**Addendum to Technical Specialist Report –
Transport – Section 42A Reporting**

**PLAN CHANGE 13 – TE RAPA
RACECOURSE PRIVATE PLAN
CHANGE**

HAMILTON CITY DISTRICT PLAN

Hamilton City Council

Figure 1: Proposed Intersection Layout (extract from Drawing 144720-00-0007, Rev E)

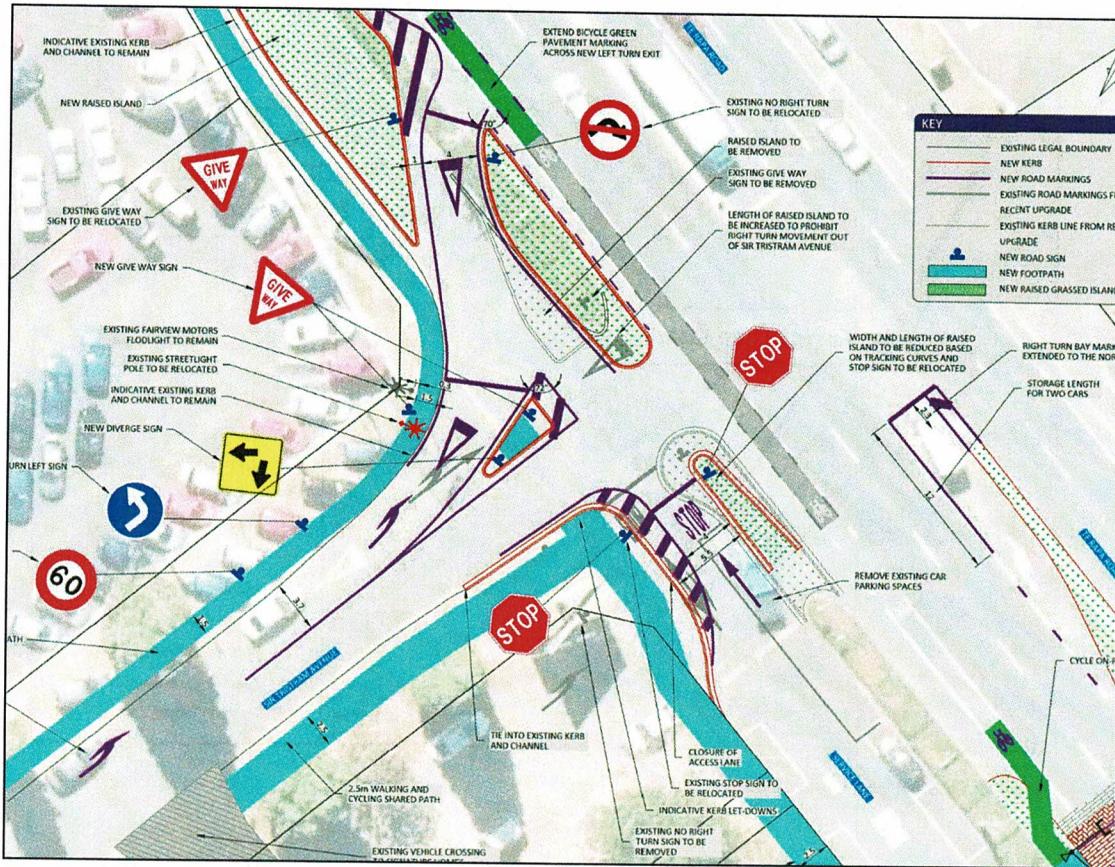
3.12 Several submitters²⁷ raised concerns with delays and crashes at the service lane exit. Since 2018 there have been no reported crashes relating to vehicles turning into or out of Sir Tristram Ave or the service lane. The proposed changes to this intersection mean that vehicles exiting the service lane only have to give way to vehicles entering Sir Tristram Ave. They will not have to give way to vehicles exiting Sir Tristram Ave as those vehicles can only turn left out. The proposed layout modifies the alignment of the exit to Te Rapa Road to improve driver visibility which should improve operation of the intersection.

3.13 I have reviewed the revised modelling provided by Mr Balachandran. I agree with him that the effects on right-turn and u-turn movements at the Te Rapa Road/ Sir Tristram Ave intersection are acceptable.

Figure 2: One Network Framework

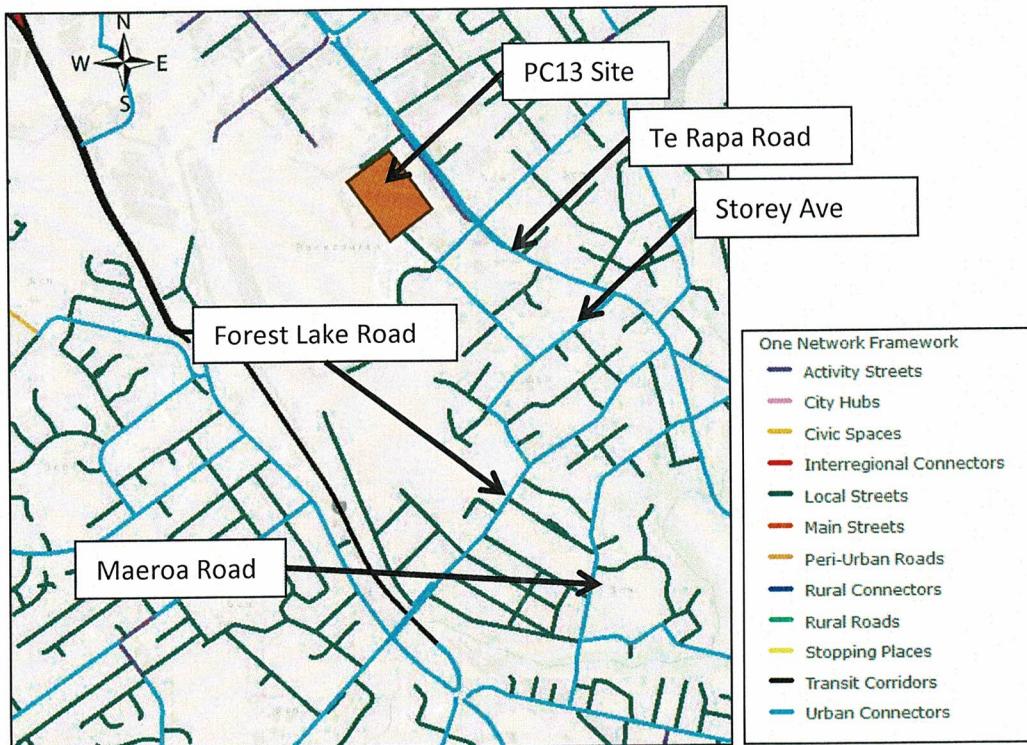
3.15 I considered the impact of the additional traffic on the Garnett Ave/ Te Rapa Road intersection in my Transportation Review²⁹. I note that Figure 6 of my Transportation Review only considered alternative routes to Te Rapa Road and does not show other Urban Connectors³⁰ that could be used for travel to/from the west and south which include employment areas at Frankton and the Waikato Hospital. The figure below shows the transport network and One Network Framework, demonstrating that there are multiple routes available for travel to/from the site that avoid intersections on Te Rapa Road.
